**GOVT OF ANDHRA PRADESH  
IRRIGATION & CAD DEPARTMENT**

Lr.No. EE/NTD/2230

Sub: HUDA – Plg. Dept. – Group Housing Scheme layout in Sy.No.32, 40(P),  
41(P), 42, 44, 45 & 55 of China Cherlapalli (V), Ghatkesar (M), R.R.Dist.  
– Furnishing Distance – Reg.

SKETCH SHOWING THE DISTANCES AT DIFFERENT POINTS ON PROPOSED GROUP HOUSING SITE  
 AND BUND OF CHERLAPALLI TANK. OF CHERLAPALLI [M]. R.R. DIST.

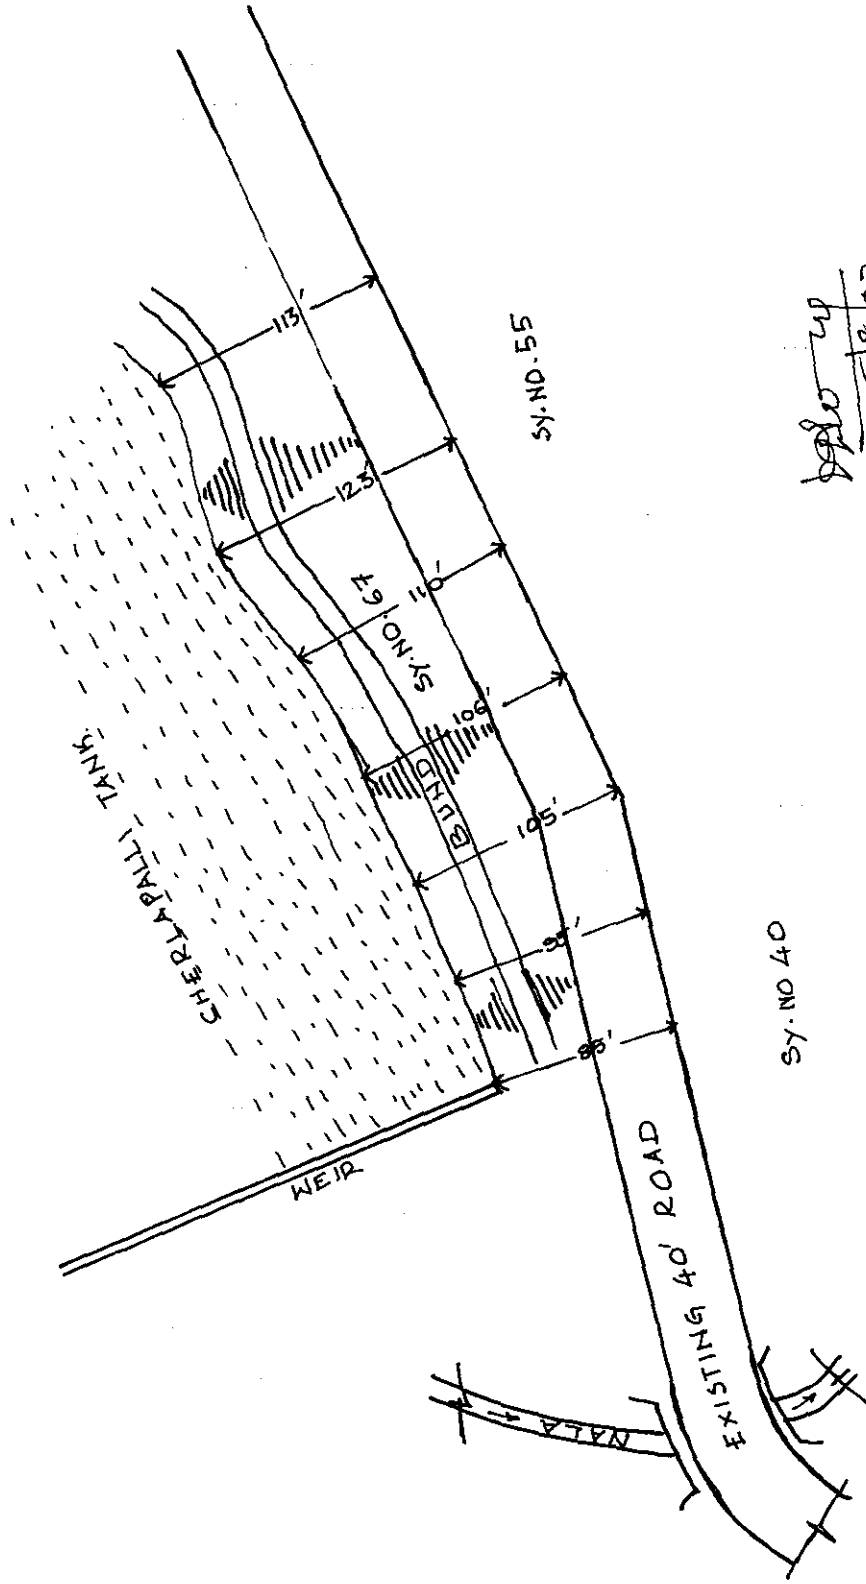
With reference to the Vice Chairman HUDA letter cited above, the  
Sy.No. 32, 40 (P), 41 (P), 42, 44, 45 & 55 of Cherlapalli (V), Ghatkesar (M), R.R.  
District are inspected and the said lands falls down stream, on Right flank of Cherlapalli  
Cheruvu, which will not be revealed as FTL lands.

Further this is to inform you that there is 100 ft. distance between inner  
side toe of Tank Bund to Outer Road formed in the site of above survey numbers except  
two points. The necessary sketch showing the distance between site developed in  
survey numbers and toe of inner side of Tank Bund is herewith enclosed duly signed.
